REMARKS

This is a full and timely response to the Office Action mailed November 27, 2007, submitted concurrently with a three month extension of time to extend the due date for response to May 27, 2008.

FIG. 2

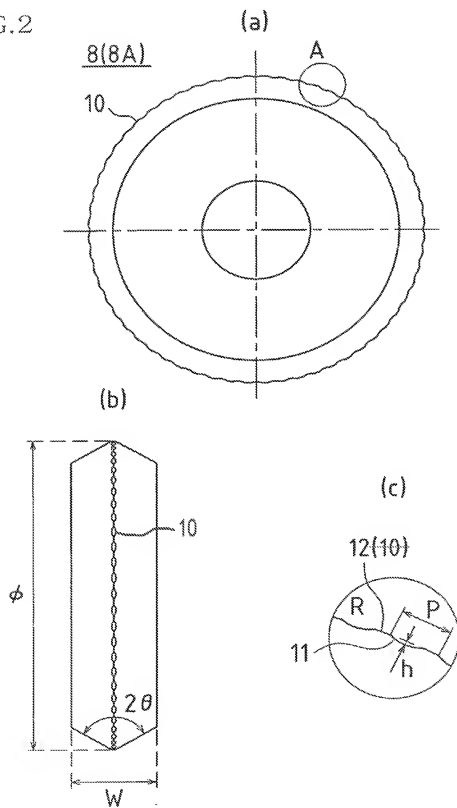
The Examiner has objected to the drawings for (1) lacking clarity in Figures 2(b), 2(c), 4, 5, 6, 7, 8, 10 and 13 and (2) failing to include the figure heading "Prior Art" for Figures 26-29. Applicant has submitted corrected formal drawings which address all of the Examiner's concerns. Thus, withdrawal of this objection is respectfully requested.
